# Site Accessibility Evaluation

**Industrial Park**  
**108 Industrial St**  
**Denton, TX 76201**

**Accessibility Evaluation**

***Inspection Date: 04/16/2021***

### Barrier: 1

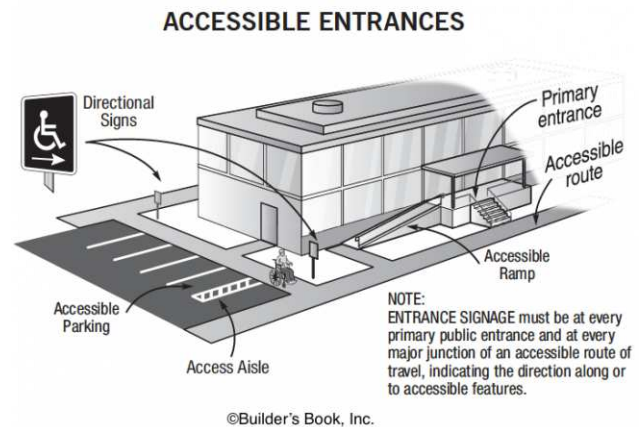
There is no accessible route to the dog waste bag dispenser.

2010 ADAS Section: 206.2.2

1991 ADAAG Section:  
4.1.2(1)

There is no accessible route  
to the dog waste bag  
dispenser.

Provide an accessible route of travel and the required clear floor space to the dog waste bag dispenser.

### Barrier: 2

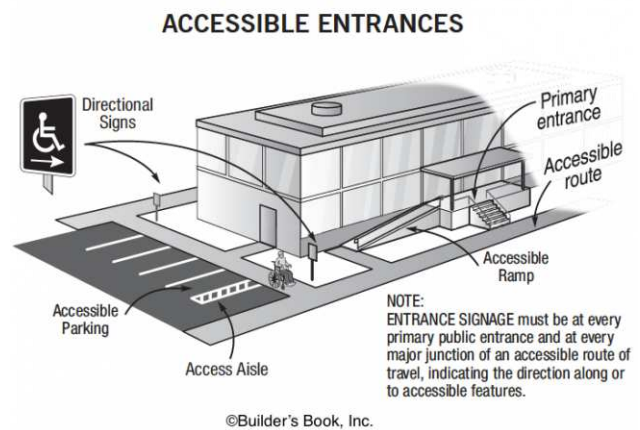
There is no accessible route to the table.

2010 ADAS Section: 206.2.2

1991 ADAAG Section:  
4.1.2(1)

There is no accessible route to the table.

Provide an accessible route of travel to the table.

### Barrier: 4

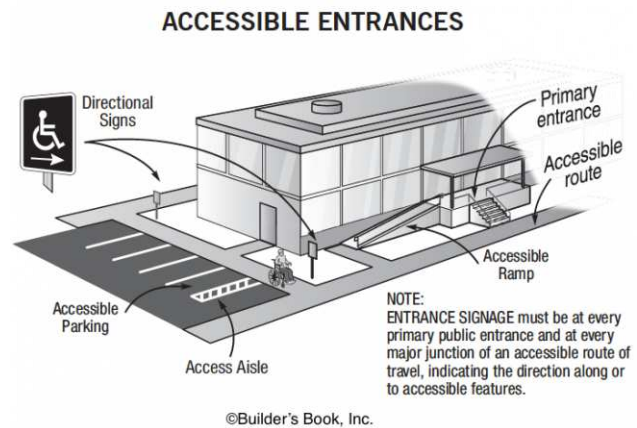
There is no accessible route to the table.

2010 ADAS Section: 206.2.2

1991 ADAAG Section:  
4.1.2(1)

There is no accessible route to the table.

Provide an accessible route to the table.
